Register Reference: SD22A/0460 AI

Development: The change of use from warehouse to data repository facility, alterations to external facades, provision of a new 1100mm parapet, reclad roof, internal alterations, refurbishment of the existing office space, solar panels at roof level, external plant at ground and roof levels and equipment to include 12 condenser modules, an emergency back-up generator and associated fuel storage tank, transformer, extension to the existing sub-station (c. 13sq.m), 2 sprinkler tanks and pumphouse, bin store, 22 parking spaces including 2 electrical vehicle charging points, bicycle parking shelter, landscaping, planting, new security fence, external lighting, CCTV, altered vehicular gates, permeable hard surfaces, alterations to internal foul sewerage and water supply networks, provision of SuDS compliant surface water drainage system and all associated site works.

Location: Unit 1, M50 Business Park, Ballymount Avenue, Dublin 12

Roads Related Additional Information Requested by SDCC:

Figure 1: Site plan with vehicle access routes shown

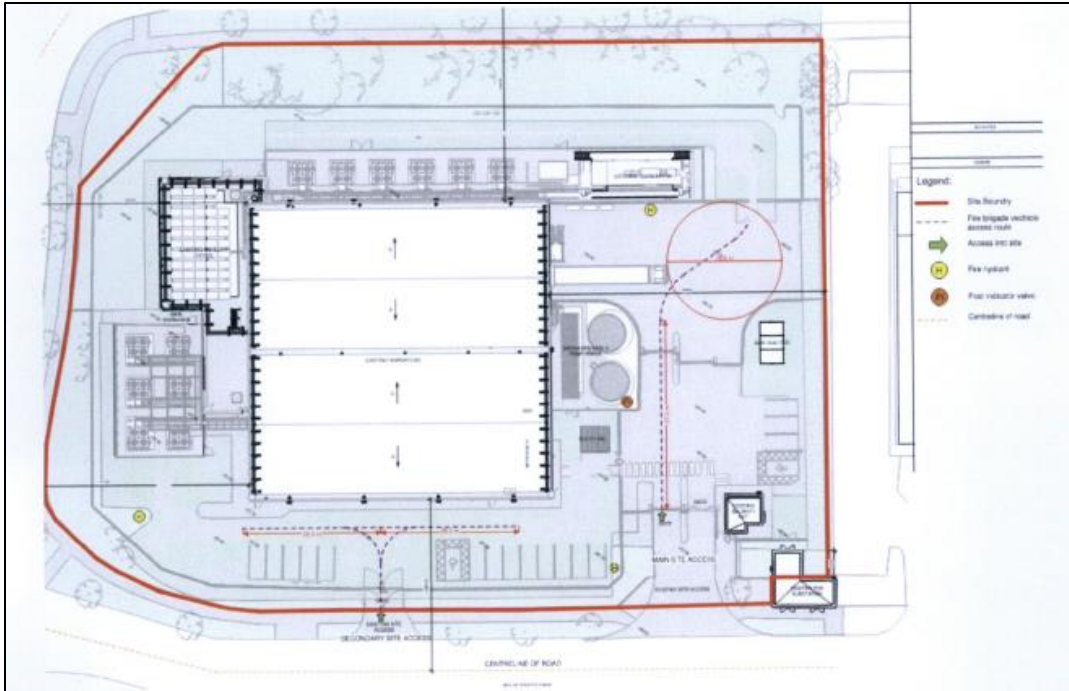
2. (i) The applicant is required to submit, for verification and record purposes, the specific advice given to them by their Fire Consultant, which details why vehicle access is not required to the north of the building.

2) (i) **The applicant is required to submit, for verification and record purposes, the specific advice given to them by their Fire Consultant, which details why vehicle access it not required to the north of the building.**

Vehicle access to the building is provided in accordance with Table 5.1 of Technical Guidance Document B, as detailed in Table 1 below:

Figure 1 below graphically represents the fire tender access provided to the building.

The vehicle access to these elevations and the associated access road will be in accordance with Table 5.2 of TGD-B for a pump appliance, as detailed in Table 2 below.

SDCC Roads Department is satisfied with the applicant's clarification.
